AEROPILOT Ltd.

SERVICE BULLETIN NO. 2006

Checking the release of the rocket parachute rescue system

Legend 540 and Legend 600

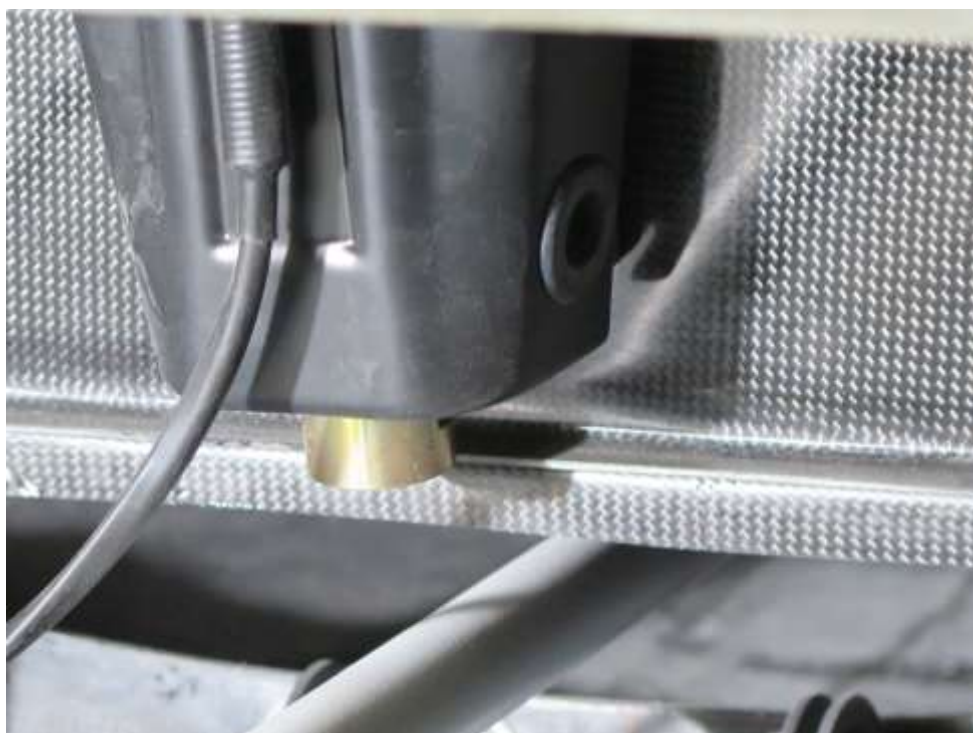
During the inspection, a gross error was found in the installation of the parachute rescue system – the unlocking (unscrewing) of the screw securing the rocket (transport fuse), see the attached photos.

Both fuses have to be removed.

Remove the cover.

Removed fuse

Removed fuse

1. Pull the seat forward and remove it from the fuselage.
2. Remove the L-shaped laminate cover behind the seats.
3. The locking screw must be removed on the left side in the direction of flight at the bottom of the rocket. At the same time, check that the wire fuse with the red flag is removed at the top of the rocket.
4. After removing both fuses, you can put the cover and continue to operate the aircraft. Otherwise, inform the manufacturer Aeropilot s.r.o.
